Access Compliance Report Public Rights-of-Way (Curb Ramps)

Intersection ID: 47708 Main Street: ERWIN_RD **Cross Street: ROCKCASTLE DR** Location: NE ADA ID: 267D04576D2A Ramp Type: PerpDiag Initial Pass/Fail: Fail **Overall Compliance: No Severity Score:** 12.5

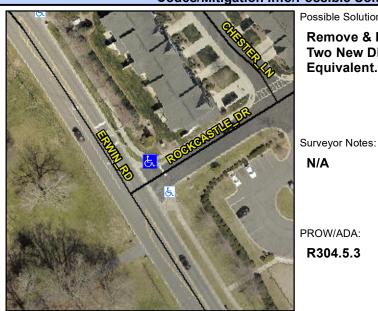
Compliance Description Data		Data	Compliance Description		Data
N/A	Ramp Length (in)	90.0	Yes	Ramp Slope (%)	6.2
Yes	Ramp Width (in)	48.0	No	Ramp XSlope (%)	5.7
N/A	Flare Type LT	N/A	N/A	Flare Type RT	N/A
N/A	Flare Slope LT (%)	N/A	N/A	Flare Slope RT (%)	N/A
N/A	Flare Traversable LT?	N/A	N/A	Flare Traversable RT?	N/A
N/A	Landing Length (in)	N/A	N/A	DWS Provided?	N/A
N/A	Landing Width (in)	N/A	N/A	DWS Contrast?	N/A
N/A	Landing Slope (%)	N/A	N/A	DWS Length (in)	N/A
N/A	Landing X Slope (%)	N/A	N/A	DWS Full Width?	N/A
N/A	Landing Curb? (Y/N)	N/A	N/A	DWS Offset (in)	N/A
N/A	Shared Landing?	N/A			
N/A	Gutter Ponding?	N/A	N/A	Gutter Slope (%)	N/A
N/A	Gutter Lip Ht (in)	N/A	N/A	Gutter X Slope (%)	N/A
N/A	Painted X Walk1?	No	N/A	Painted X Walk2?	No
	X Walk 1 Direction	To SW		X Walk 2 Direction	To SE
N/A	X Walk 1 Width (in)	N/A	N/A	X Walk 2 Width (in)	N/A
	X Walk 1 Slope (%)	2.6		X Walk 2 Slope (%)	1.3
	X Walk 1 X Slope (%)	1.2		X Walk 2 X Slope (%)	0.2

ERWIN RD None **ROCKCASTLE DR** StopSign Possible Solutions: Remove & Replace Curb Ramp With Two New Directional Ramps or
